Contract #: 04-0120F4Cty: SF/ALA Rte: 80 PM: 13.2/13.9File #: 69.25B**QUALITY ASSURANCE -- NON-CONFORMANCE REPORT****Location:** Changxing Island, Shanghai, P.R. China**Report No:** NCR-000657**Prime Contractor:** American Bridge/Fluor Enterprises, a JV**Date:** 27-Jan-2010**Submitting Contractor:** Zhenhua Port Machinery Company, Ltd (ZPMC), Changxing Island**NCR #:** ZPMC-0628**Type of problem:**

Reference Description: UT Indication discovered after ZPMC had tested and accepted this weld in Segment 8CE Side Panel to Side Panel

Subject: NCR No. ZPMC-0628

WELD NUMBER: SEG048B-032

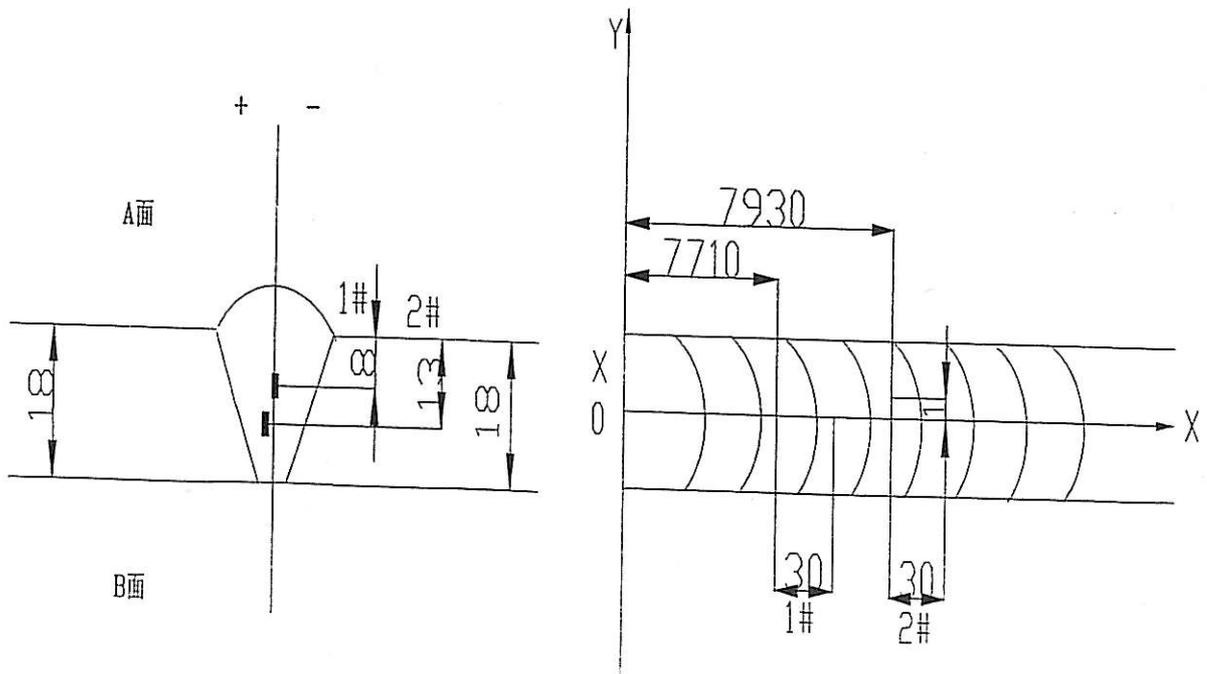
Rejected indication found by ultrasonic inspection is less than the maximum allowance aggregate length.

(UT探伤发现的缺陷总长度小于最大允许长度。) SEG048B-032

1、焊道未及时处理干净。

1. Did not clear the weld pass completely in time.

1. Gouge or grind from nearer side from metal edge ($D \leq 0.65T$, "D" is depth of defects, "T" is thickness of metal) to remove all defects;

2. Follow repair WPS for joint preparation, preheat, and weld deposit;

3. Verify with VT no defects remain in the weld joint prior to welding;

4. Grind the repaired area flush with base metal or the adjacent weld;

5. Perform UT inspection to the weld along with 50mm on each end of the repair area;
